Great Northern Transmission Line
GIS Map Comment Form

Comment: Re: Bill Grays Private Airstrip
Located in Sec. 20 Twp 67 Rg 25

GNTL Scoping Meetings
7/16/2014

GREAT NORTHERN TRANSMISSION LINE

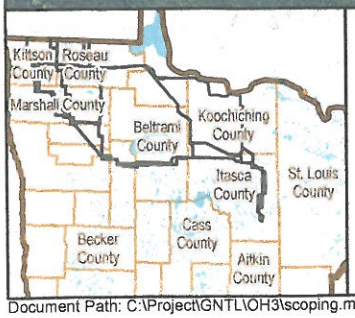
This Comment Now directed to The Possible Alternate Route for The Great Northern Line Which would ~~Bad~~ Run approximately ½ mile west of The Exsisting Airstrip. I have owned 8 Aircraft over Several years and have had frequent Contact with Bill Gray who is a Qualified FAA Inspector: AI. and Instructor: CFII. I have landed at His Strip Several Times for Maintinance and Repair. He has Conducted Annual Inspections of Aircraft and given Bi-Ennial Flight Reviews to for me.

The Line, if Placed in The Proposed Alternate Location Through Sec. 20 would be a Significant Hazard to Air Traffic to and from his Airstrip.
